Zion Nuclear Power Station, Units 1 and 2  
Facility Operating License Nos. DPR-39 and DPR-48  
NRC Docket Nos. 50-295 and 50-304

**Subject:** Submittal of Defueled Safety Analysis Report Update, Revision 6  
Report of Changes, Tests and Experiments

**ZION NUCLEAR POWER STATION  
DEFUELED SAFETY ANALYSIS REPORT REVISION 6**

Figure 3-45

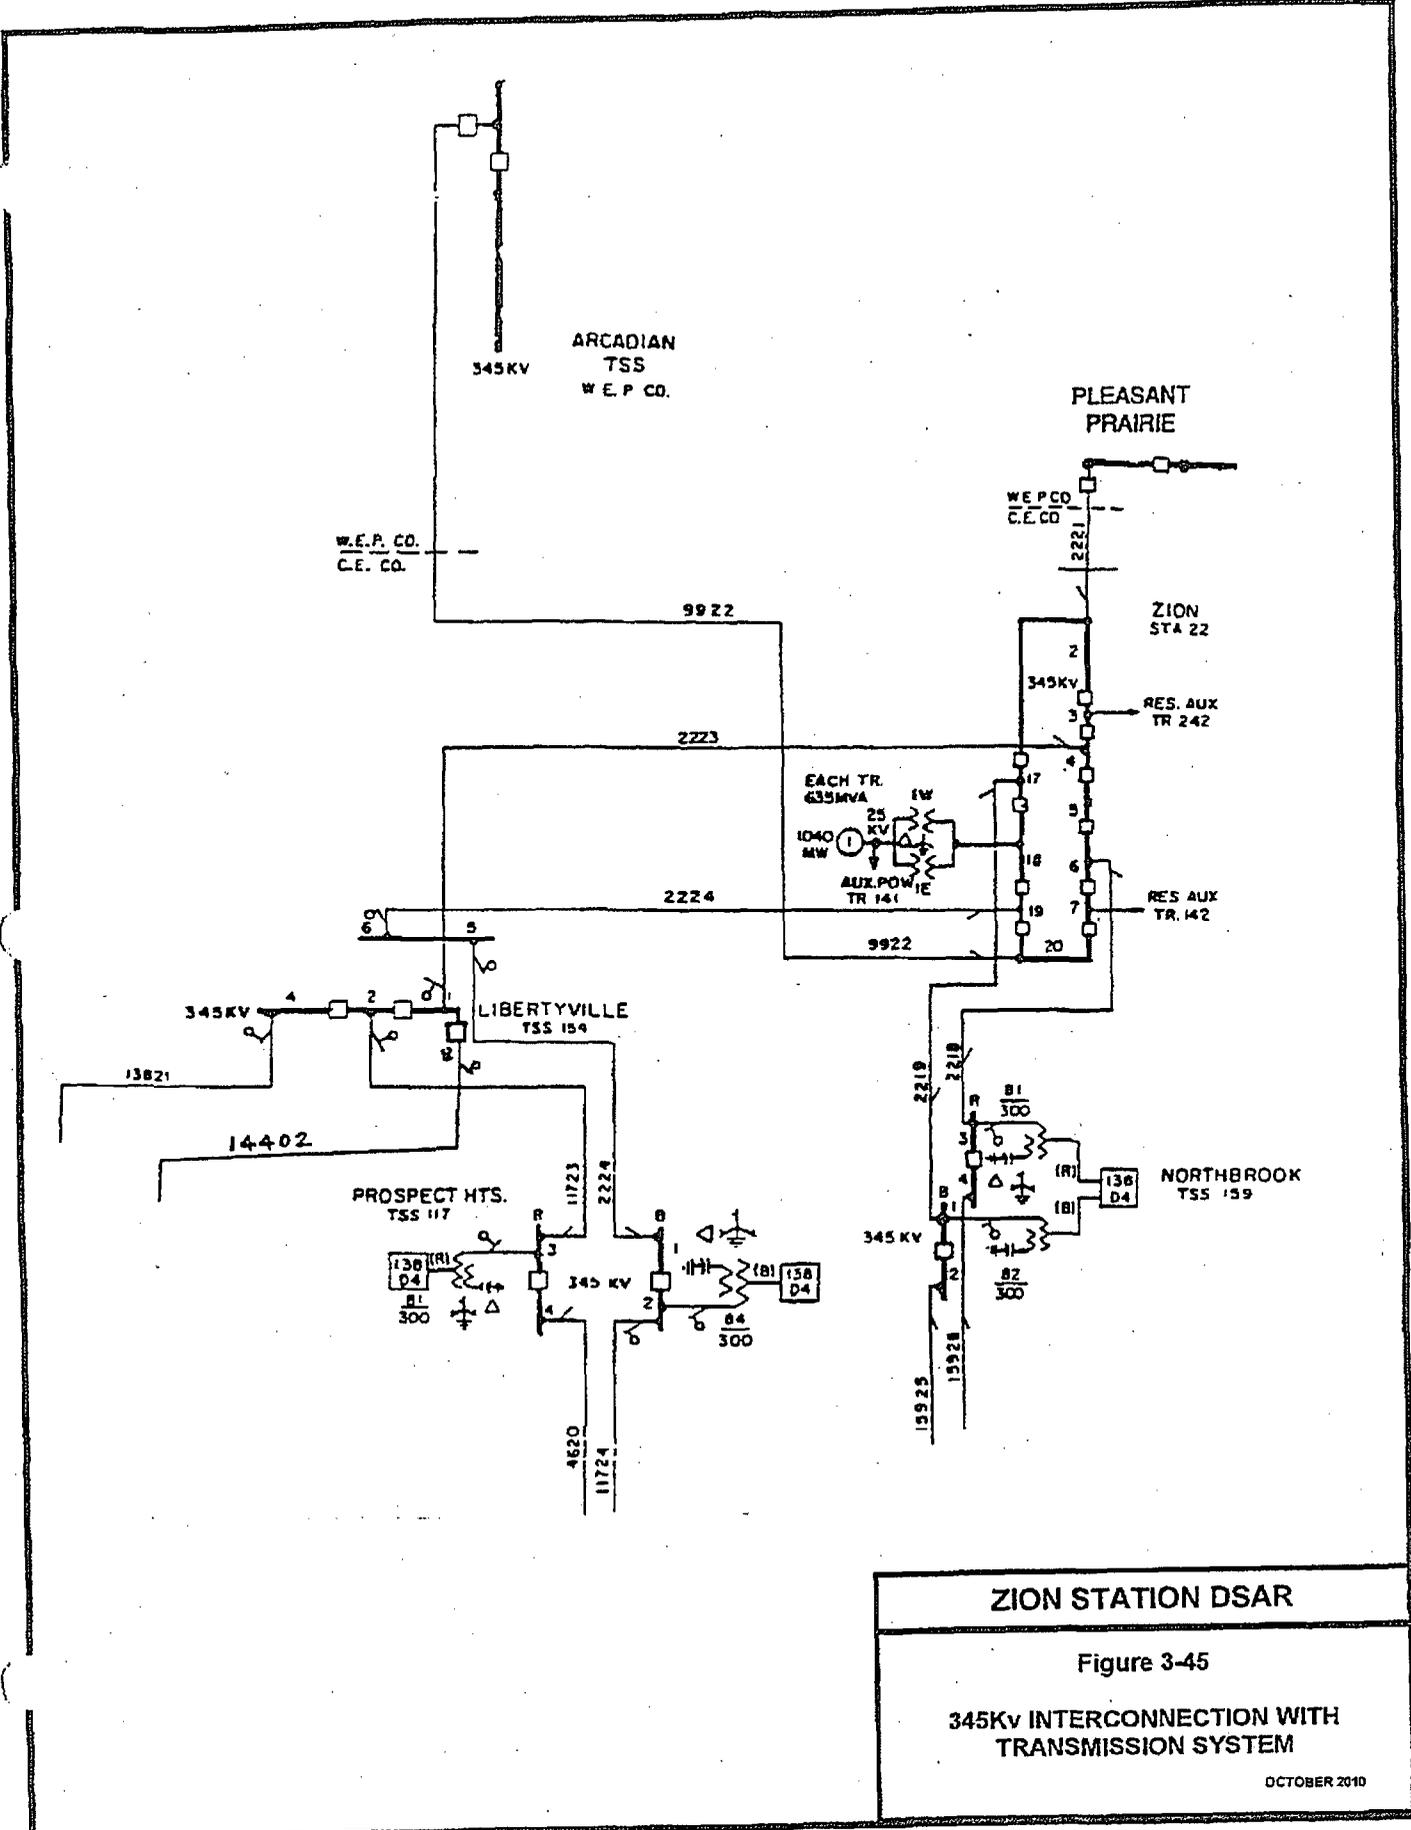
Pages	Description of Change
Page 3-55, Figure 3-45	Delete references to Unit 2 Main Power Transformers and Unit Auxiliary Transformer which have been physically removed.
Pages, 3-50, 3-52a, 3-60, 4-13, Figures 3-41, 3-42, 3-42A, Table 4-3	Eliminate discussion of Fuel Building ventilation system and associated effluent radiation monitors since the Fuel Building has been reconnected to the Auxiliary Building ventilation system.
Page 3-47, Figure 3-40	Revise system description to reflect Service Water Booster Pump supply isolation to traveling screens and copper injection system.
Pages 1-1, 1-4, 1-5, 1-6, 1-9, 2-1, 3-4, 4- 1, 4-3, 4-5, 6-1, 6-4, 6-5	Update document to reflect license transfer from Exelon Generation Company (EGC) to Zion Solutions (ZS).
